SUBJECT: BRUNSWICK STEAM ELECTRIC PLANT, UNIT NO. 2 - REQUEST FOR RELIEF FROM THIRD 10-YEAR INTERVAL INSERVICE INSPECTION PROGRAM PLAN REQUESTS FOR RELIEF RR-29 AND RR-30 FOR BRUNSWICK STEAM ELECTRIC PLANT, UNITS 1 AND 2 (TAC NOS. MB5854 AND MB5855)

SAFETY EVALUATION BY THE OFFICE OF NUCLEAR REACTOR REGULATION

REQUESTS FOR RELIEF RR-29 AND RR-30

BRUNSWICK ELECTRIC PLANT, UNITS 1 AND 2

- Typical Cross-Section of BWR Nozzle with Internal Piping

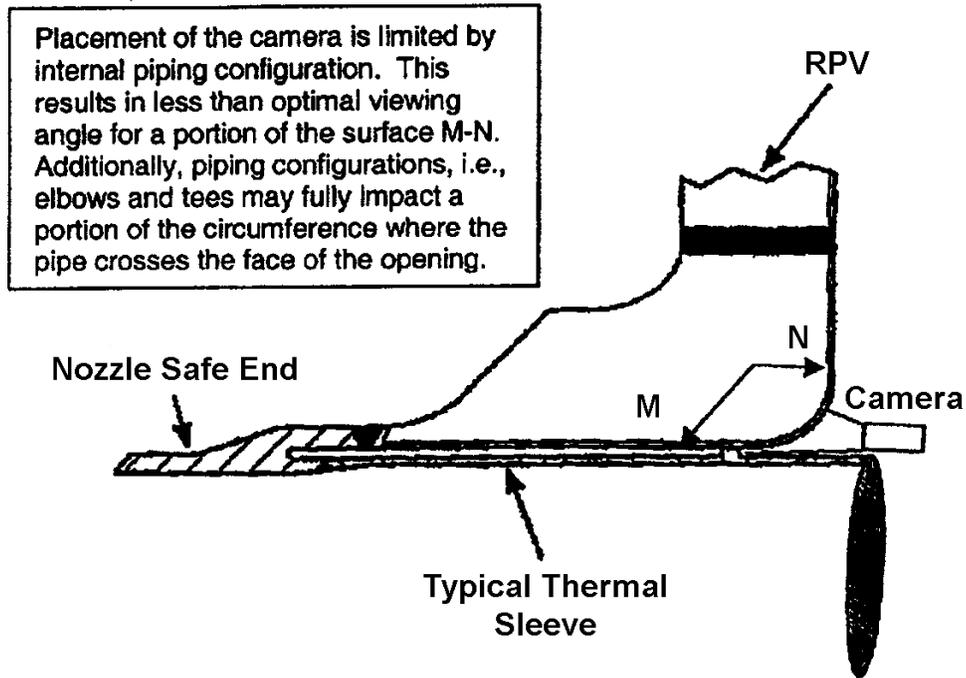
Visual examination of the inner radius region of the specified nozzles is limited because the reactor internal piping configuration prevents placement of the camera in all

positions necessary to examine surface M-N over the full circumference (i.e., see Figure 1 below).

The specific nozzle limitations and estimated coverage are as follows:

Nozzle Type/Number	Limitation	Estimated Coverage
Core Spray (2 nozzles)	Thermal Sleeve and Sparger	40%
Reactor Recirculation Inlet (10 nozzles)	Thermal Sleeve/Jet Pump Riser	50%
Jet Pump Instrumentation (2 nozzles)	Instrumentation Lines	60%

The staff finds that while improved UT technology is applied from the outside surface, the complex geometries and extended sound paths for these RPV nozzle inner radius sections may prevent full volumetric coverage. For the components listed above, the licensee proposed to perform what has been identified as an enhanced VT-1 (EVT-1) visual examination on the accessible portions of the nozzle inner radius sections in lieu of UT. These will be remote examinations conducted from the vessel interior. Enhanced in this case refers to the ½-mil wire standard that is to be demonstrated by the examiners to assure acceptable sensitivity. The license stated that estimated coverages will be in the range of 40-60% for the inner surfaces of the subject nozzle inner radius sections. The licensee also indicated that measures described in the EVT-1 procedure will be taken to assure that examination parameters, including lighting, lens-to-object distances, water clarity and surface conditions will be adequate to detect the smallest expected anomaly, i.e., a fatigue crack whose surface opening is greater than ½-mil, for the duration of these examinations.

The staff determined that considering the personnel radiation exposure that would be incurred if the licensee was required to perform the Code volumetric examinations it would result in a significant hardship without a compensating increase in quality and safety. Furthermore, the staff determined that the potential of the EVT-1 visual examinations to detect thermal fatigue degradation in the inspected regions of the nozzle inner radius sections, the absence of any historical industry evidence for cracking in the subject components, and the volumetric examinations being performed on other similar nozzles, provides reasonable assurance of the continued structural integrity of the subject nozzles has been provided. Therefore, it is recommended that, pursuant to

10 CFR 50.55a(a)(3)(ii), the licensee's proposed alternative to use EVT-1 visual examination in lieu of volumetric for the nozzle inner radius sections listed in Request for Relief RR-29, Revision 1, should be authorized.
